Solicitation RFIs – Spinal Cord Corridor Project

Solicitation RFI - DRAWING - Spinal Cord Corridor Project

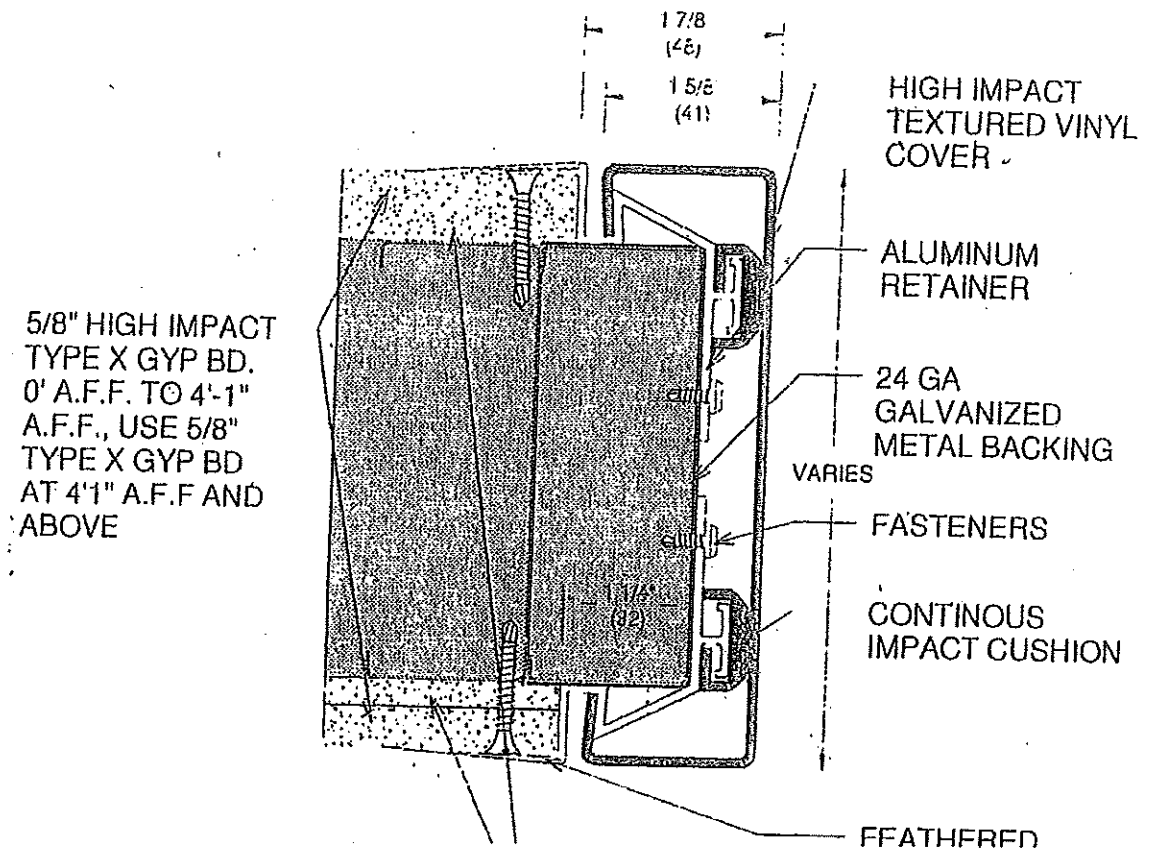
46. InPro is being specified for handrails, chair rails, and corner guard 1. We assume Inpro is also acceptable for CG-2 and Wall Guard-1. Please clarify otherwise if this is not a correct assumption.

Ans – CG-2 Pawling Corporation, CGF-888, 1 hour, Fire Rated endwall protection, brown- or equivalent. / Wall Guard WG-1 Inpro 700W, woodland group, 0535, honey nut
